Review 1

Preliminary and Final Major Site Plan
197 Ave. E Urban Renewal, LLC
Peninsula Lofts

197 Ave E
Block 221, Lot 12.01
Villanova Site Redevelopment Area

April 28, 2023

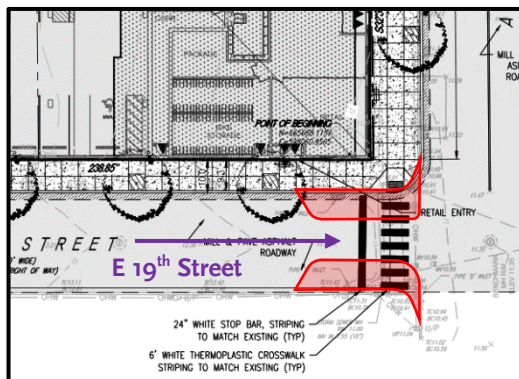
4.3. **Parking Stall Dimensions.** The applicant is proposing three types of parking stalls: standard, compact and barrier free.

4.3.1. Per §2.1.B.3.ii.1, standard parking stalls are required to be a minimum of 8.5 feet wide and 18 feet deep. The applicant is proposing 214 standard parking stalls, all of which are 8.5 feet wide and 18 feet deep. The plan complies.

4.3.2. Per §2.1.B.3.ii.2, compact parking stalls are required to be a minimum of 7-feet 4-inches feet wide and 16 feet deep. The applicant is proposing 28 compact parking stalls, all of which are 8 feet by 16 feet. The plan complies.

4.3.3. Per the Barrier Free Sub-Code, the applicant is required to provide 7 barrier free spaces for the number of total spaces, of which two spaces are required to be van

Proposed Striping on E 19th Street and Recommended Curb Extensions (Red)

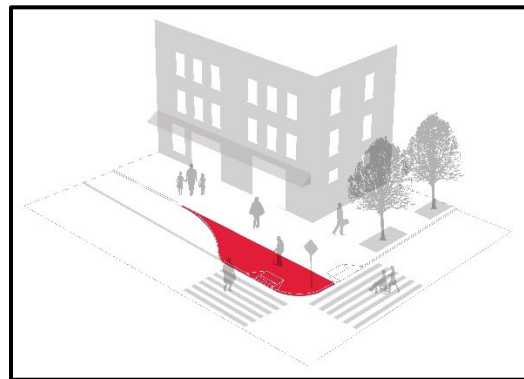
- 4.8. **Traffic Calming.** Per 2.1.C.2.3, all streetscape improvements shall be designed in accordance with Section 15 (Traffic Calming) of the NJDOT Roadway Design Manual.¹ In lieu of the standard one-way stop bar and crosswalk proposed at the intersection of E 19th Street and E Avenue, a curb extension into the right-of-way, also known as a bump out or a neckdown, may be warranted consider the high level of residential density in the neighborhood and observed foot traffic. This would shorten the length of the crosswalk for pedestrians and also makes the crosswalk itself more visible. On-street parking within 25 feet of the crosswalk would be replaced by a curbed island that may have various kinds of street furniture built into the design, depending on need. **This concept will need to be discussed with the Department of Public Works and the City Engineer to determine policy.**
